Community Feedback on Preliminary Design Concept

The Murray CSO Control Facility preliminary design concept drawings were shared with the public in January 2012. The drawings were very early, conceptual attempts to marry the community's expressed vision for the site with the constraints identified through site and technical analysis.

The Murray CSO Design Advisory Group (DAG) offered the following comments about the design concept at its January 12, 2012 meeting:

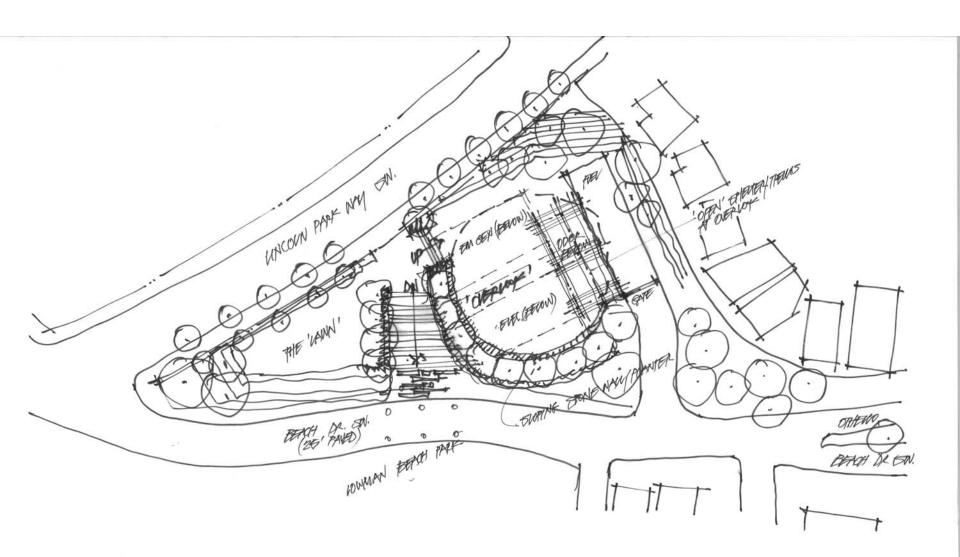
- The concept looks like a lot of the concepts from the previous meetings and design workshop. The Design Workshop drawings are definitely being used.
- This design is responsive to the group's comments. The drawings need to more clearly identify the small access point to Othello, which is slightly to the left of the Beach Drive dead end opening.

- These drawing are primarily about the architecture of the building. The community should be able to sculpt the landscape. Softening the edges could change the entire view of the building without moving much of the facility itself.

- The drawings represent a great conceptual move forward and do a good job capturing the group's comments. The drawings give the group a good look at a potential new asset the stair step which will provide beautiful views west. Is there a way to soften the edges?

- Consider moving back the screen to give back more public space. The project team should start thinking of the facility less as an actual building and more as landscaping or land form.

- It looks like there is a lot of concrete in front of the facility. Could that area be gravel?
- Has an inventory of trees along the Murray Avenue right-of-way been done?
 (Answer: Not yet, but an inventory will be conducted.)

- A strong preference was expressed for the rounded street concept as it can easily meld with the beginning of the park. Interest in the sidewalk on the Lowman Park side of the street being curved to match the rounded street and visually connect the two properties.

The following design suggestions were developed by community members Patrick Gordon and John Bernhard and shared with King County on January 30, 2012.

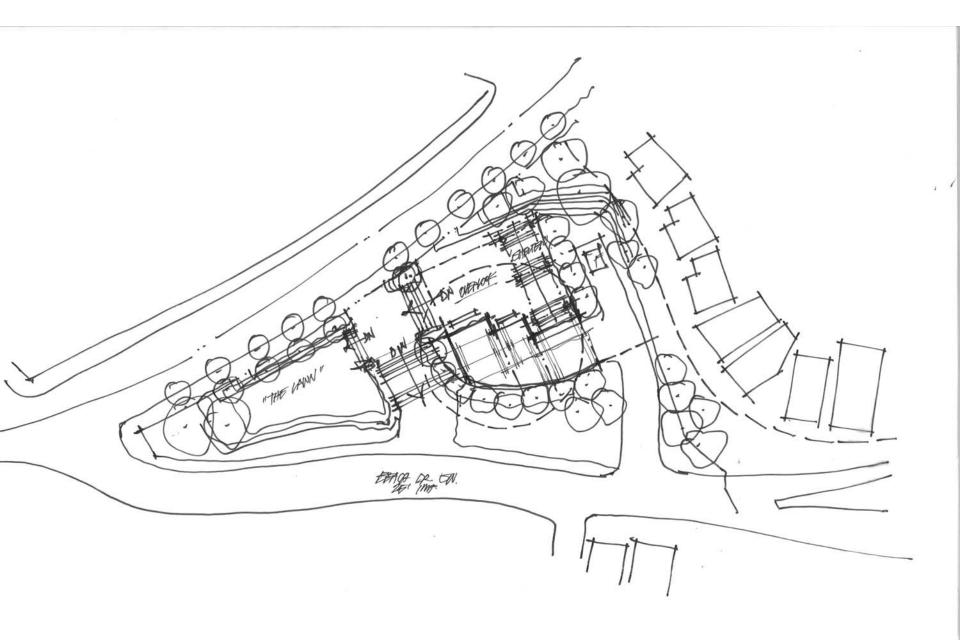
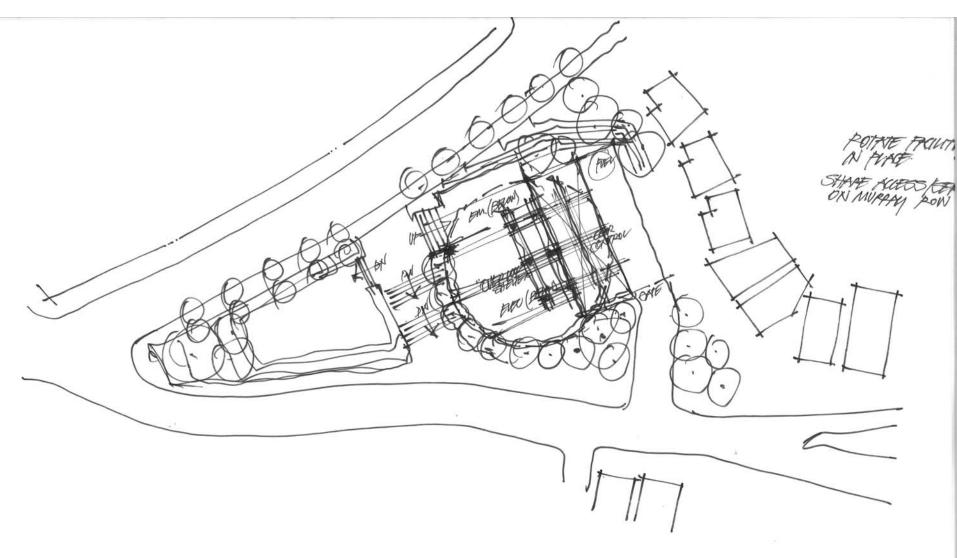
- Turn the equipment configuration 90 degrees so that the building orientation faces south instead of west.
- Reconfigure the odor control access area currently running north-south immediately west of the buildings to run east-west adjacent to the Murray Avenue right-of-way.

- Utilize the Murray Avenue right-of-way to access the facility in a combined location, freeing up the site's north end for open space.
- Reconfigure buildings to run east-west over the circular tank rather than north-south along the hillside.

- Combine the building and landscape to accommodate the facility's functional requirements and create an overlook and pedestrian pathway.
- Mediate topographic transitions so that the site is more about the "place" than a "building".

- Replace the staircase with terraces and pedestrian access as a part of the buildings with a curving path/staircase immediately north of the facility.

- Use trees and berms to create a wall along the curving pathway's southern boundary to mask the facility from the sight of park users and pedestrians on Beach Drive

- Link the curving path to an overlook on top of the facility.
- Use screens to mask views of the odor control access and facility from the overlook.
- Use "Ha-ha" architecture techniques to mask the odor control access area from the view from the overlook. A ha-ha is a landscape architecture technique that creates a barrier while allowing an unbroken view of the landscape.
